Thermostat Change – 75 thru 115

Mariner and Mercury 1991 75-115

Starting Serial Number of 120° F Thermostat

120°F Thermostat P/N 14586

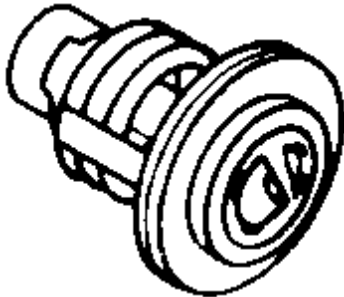
Previous 70/75/80/90 3 cylinder and 100/115 4 cylinder models have a 143°F thermostat installed. Operation at idle for long periods of time in extremely warm water (80°F and above) could cause the block to function hotter than desired. Installation of the 120°F thermostat improves the durability of the engine when operated for long periods at idle.

Carburetor Anti-Icing Kit p/n 75692A12 contains the 143°F thermostat and will be superseded to a p/n 14586A-5 kit which contains the 120°F thermostat. Both kits work equally well to prevent carburetor icing. When an anti-icing kit is installed, the thermostat in the kit should match the thermostat installed in the engine. If the thermostats do not match, it will not cause the powerhead to fail. However, the cooling system will operate more efficiently when the two thermostats are the same temperature.

Thermostat Combination:

143°F Carburetor Anti-Icing Kit P/N 75692A12 installed on a powerhead with a:

-143°F thermostat.
Thermostat combination is correct.

- 120°F thermostat.
Change kit thermostat to 120°F.

120°F Carburetor Anti-Icing Kit P/N 14586A-5 installed on a powerhead with a:

-143°F thermostat.
Change powerhead thermostat to 120°F.

- 120°F thermostat.
Thermostat combination is correct.
